**AMERICAN FORK CITY  
NOTICE OF PUBLIC HEARING  
PLANNING COMMISSION REGULAR SESSION  
February 8<sup>th</sup>, 2023  
7:00 p.m.**

Review and action on a Site Plan application for the DBN Tax Project, located at 34 W 100 N, in the Central Commercial (CC-1) Zone.

# DBN TAX BUILDIGN SITE – 34 W 100 N, American Fork Utah

## RESPONSE TO CITY COMMENTS AS OF 15 NOV 2022

## PROPOSED ZONE CHANGE

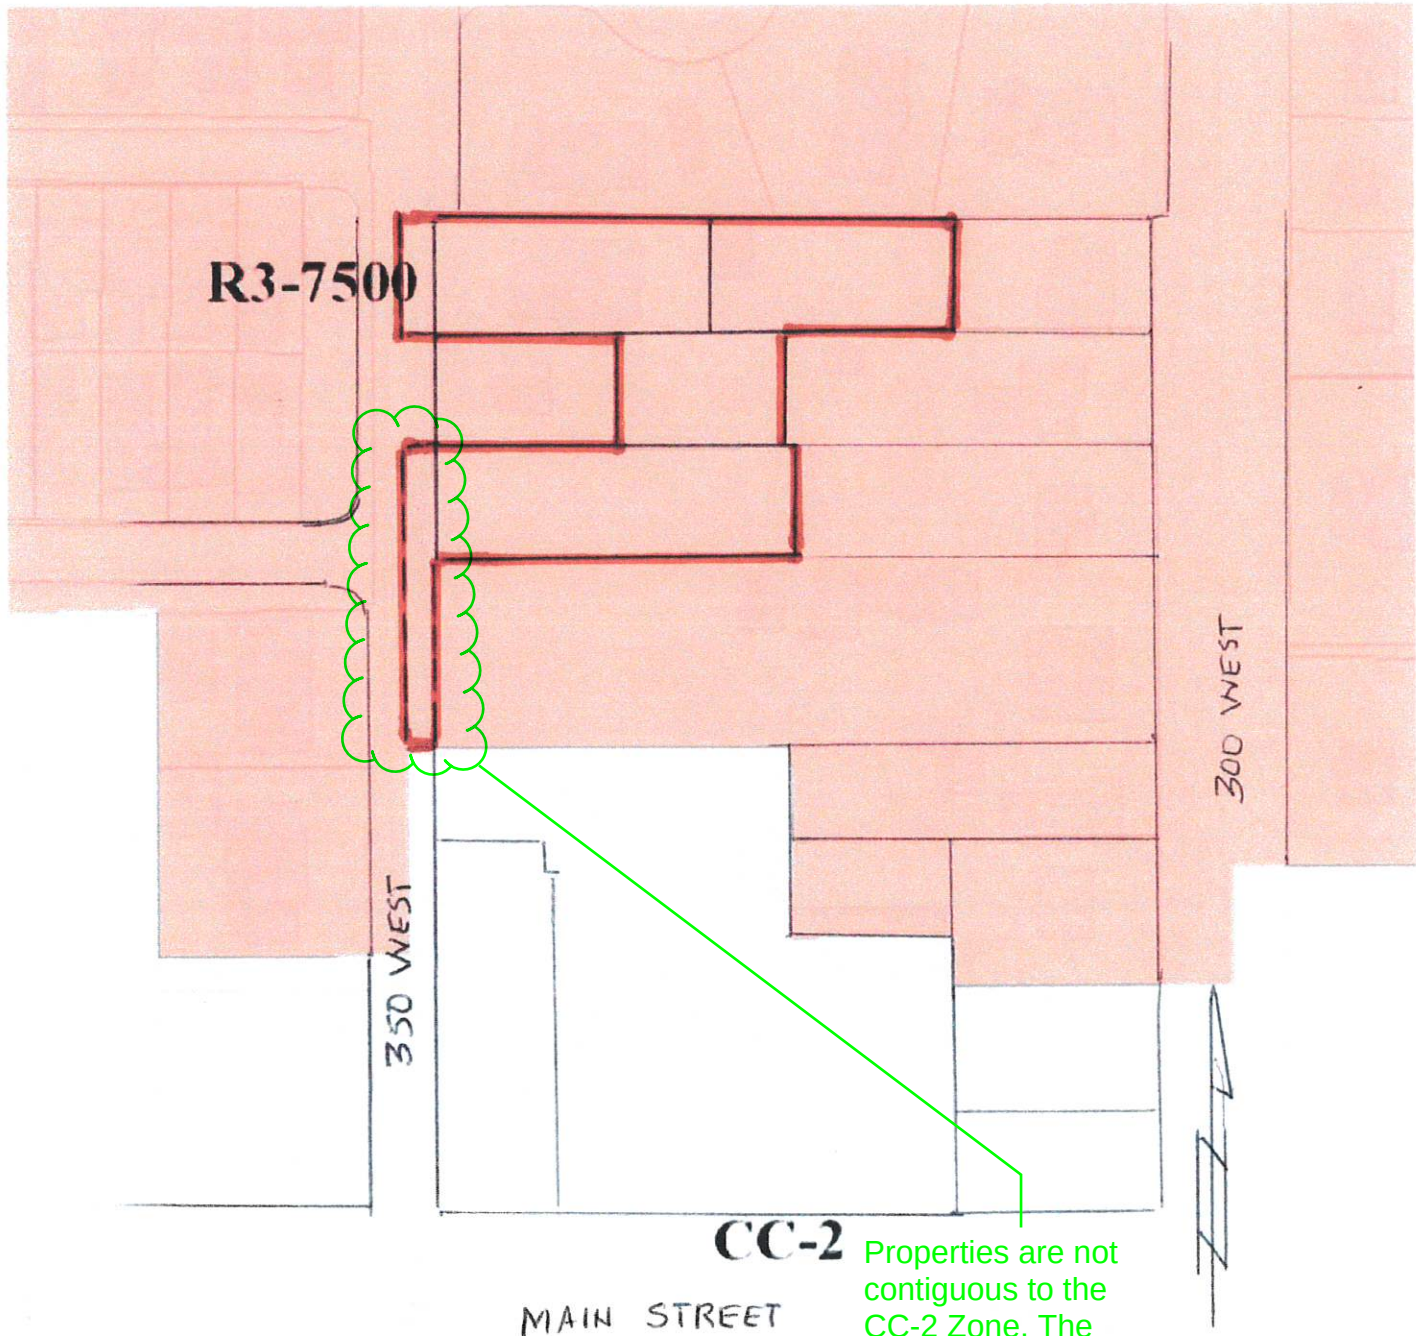
Properties are not  
contiguous to the  
CC-2 Zone. The  
street is City property  
and rezoning half of  
the street will not be  
possible for  
connectivity.

ROW necessary for 350 West shall be dedicated  
within 60 days or with submittal of a plat.

S-1

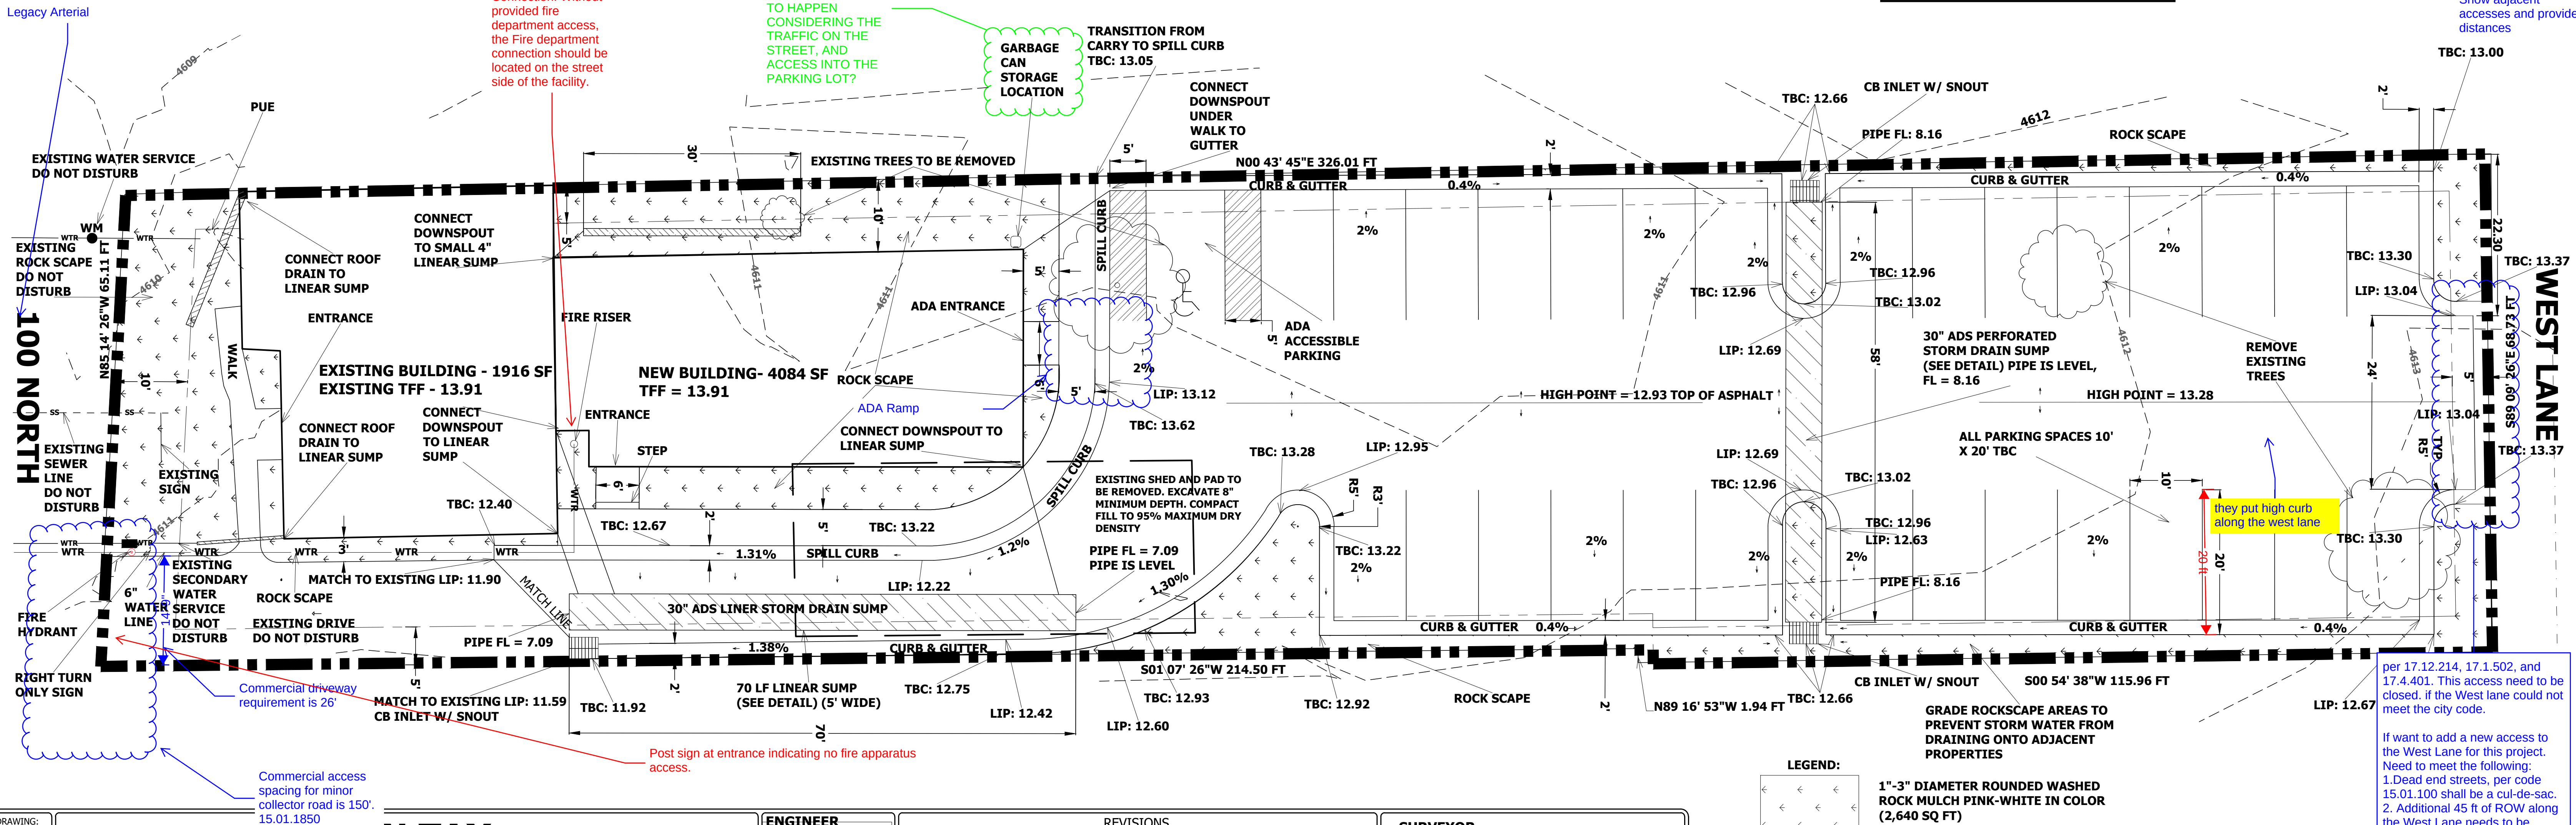
show PUE/dimensions

CAN WE GET SOME DETAILS ON TRASH PICKUP AND HOW YOU ARE PLANNING ON THIS TO HAPPEN CONSIDERING THE TRAFFIC ON THE STREET, AND ACCESS INTO THE PARKING LOT?

Provide location of Fire Department Connection. Without provided fire department access, the Fire department connection should be located on the street side of the facility.

Please confirm this with Planning per Sec 17.12.214 Nonconforming building or structure. A building, or structure, or portion thereof which does not conform with the current setback, height or other zoning regulations applicable to the structure, but which legally existed before the effective date of the now controlling regulations.

Include fire hydrant detail. Move fire hydrant into the ROW, 18" behind curb

Show the location of existing RMP infrastructure. Coordinate with RMP to relocate underground utility is being using, please remove the overhead line and reconnect to the existing buried utility near by the property.

Show how you're proposing to tie into the existing ground. Provide existing and proposed grades at property lines

Show the location of the groundwater monitoring station per American Fork Sensitive Lands

Show adjacent accesses and provide distances

per 17.12.214, 17.1.502, and 17.4.401. This access need to be closed. if the West lane could not meet the city code.

If want to add a new access to the West Lane for this project. Need to meet the following:  
1. Dead end streets, per code 15.01.100 shall be a cul-de-sac.  
2. Additional 45 ft of ROW along the West Lane needs to be provide

FIRE HYDRANTS. There are 3 fire hydrants within 250 feet of the building as stated on the plan. However, a new hydrant will be constructed in the planter strip in the SE portion of the site near the driveway. Note 3 on original submittal changed to reflect this.

NEW FIRE LINE. A new 6" fire line will be added to the plan. It will tap into the City line in 100 North St. proceed northerly into the site parallel to and 3' East of the existing building. It will terminate near the SE corner of the new addition where a FDC and riser will be located.

TRASH. Trash/garbage service will be as is currently provided with a residential container. Location of storage is shown on plans with a note.

DEPTH TO GROUNDWATER. This is not a problem because the bottom of the linear sump pipe will still be 3' above the existing GW depth. With the addition of the parking lot subgrade and asphalt, the depth to GW will be > 8'. A Note was provided to provide monitoring well for groundwater depths less than 8'

UNDERGROUND UTILITIES. Note added but the RMP facilities will not be impacted and therefore do not need to be relocated underground.
